City of Santa Fe, New Mexico

memo

2025-009690-HDRB, 1525 Canyon Rd, Downtown & Eastside Historic District, Contributing, Rachel Heydemann, agent/owner, proposes to replace windows and doors and stucco. An exception is requested to 14-5.2(D)(5)(a) to replace historic windows and doors.

Figure 3: Window schedule

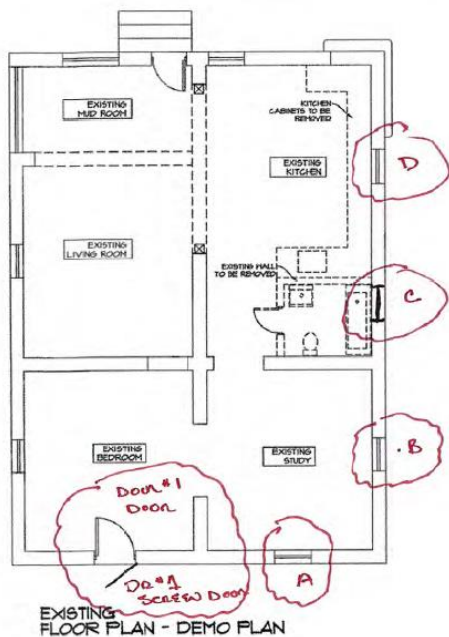
Window A, located on the south (primary) elevation and window B, located on the east (primary) elevation are both historic windows which the window assessment calls out as being in fair condition. According to the window assessment, “Note, that though the sills are buried in the wall with a flush concrete sill added to exterior. Since the sills are flush it is allowing water to run back into the adobe wall causing damage.”

The window assessment continues, “To resolve this issue, the window would need to be removed, and the sills replaced and protrude slightly to exterior like they were originally. The problem is the windows perimeter jamb is also the buck for the opening, meaning the window would be destroyed during removal. Therefore, a new window will need to be made in like and kind for the two windows.”

The window assessor also points out that Window D on the east elevation is in fair condition with historic jambs, but the sashes are not original.

While window C on the east elevation is not historic, it is in fair condition and the assessor recommends replacing all four windows and one door on the south and east elevations with in-kind to that era either wood or clad exterior/wood interior and divided light windows.

Staff finds that all the exception criteria have been met and recommends approval to replace the historic windows in-kind on the primary facade and recommends approval of window replacement on non-primary facades as they comply with 14-5.2(D) General Design Standards for all Historic Districts, and 14-5.2(E) Downtown and Eastside Design Standards.
